Access Compliance Report

Public Rights-of-Way

(Curb Ramps)

Intersection ID: 21469	Main Street: HOLLY_LN	Cross Street: SARDIS_RD	Location: SW
ADA ID: 75E2AB90AEE3	Ramp Type: PerpDiag	Initial Pass/Fail: Fail	Overall Compliance: No
Severity Score: 22.5			
Codes/Mitigation Info/Possible Solution		Field Measurements/Component Compliance

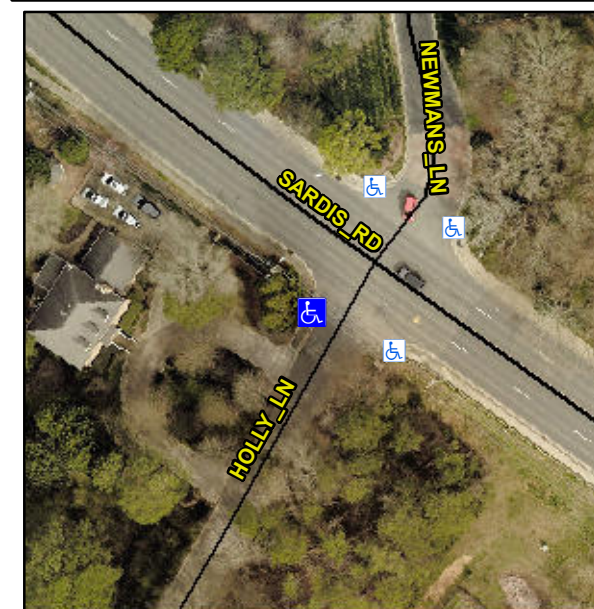
Not Found, R304.5.1, R304.2.2, R304.5.3

Compliance	Description	Data	Compliance	Description	Data
N/A	Ramp Length (in)	60.0	No	Ramp Slope (%)	9.4
No	Ramp Width (in)	39.0	No	Ramp XSlope (%)	3.8
N/A	Flare Type LT	N/A	N/A	Flare Type RT	N/A
N/A	Flare Slope LT (%)	N/A	N/A	Flare Slope RT (%)	N/A
N/A	Flare Traversable LT?	N/A	N/A	Flare Traversable RT?	N/A
N/A	Landing Length (in)	N/A	N/A	DWS Provided?	N/A
N/A	Landing Width (in)	N/A	N/A	DWS Contrast?	N/A
N/A	Landing Slope (%)	N/A	N/A	DWS Length (in)	N/A
N/A	Landing X Slope (%)	N/A	N/A	DWS Full Width?	N/A
N/A	Landing Curb? (Y/N)	N/A	N/A	DWS Offset (in)	N/A
N/A	Shared Landing?	N/A			
N/A	Gutter Ponding?	N/A	N/A	Gutter Slope (%)	N/A
N/A	Gutter Lip Ht (in)	1.0	N/A	Gutter X Slope (%)	N/A
N/A	Painted X Walk1?	No	N/A	Painted X Walk2?	No
	X Walk 1 Direction	To SE		X Walk 2 Direction	To NE
N/A	X Walk 1 Width (in)	N/A	N/A	X Walk 2 Width (in)	N/A
	X Walk 1 Slope (%)	4.9		X Walk 2 Slope (%)	1.7
	X Walk 1 X Slope (%)	4.4		X Walk 2 X Slope (%)	3.1

Remove & Replace Curb Ramp With Two New Directional Ramps or Equivalent.
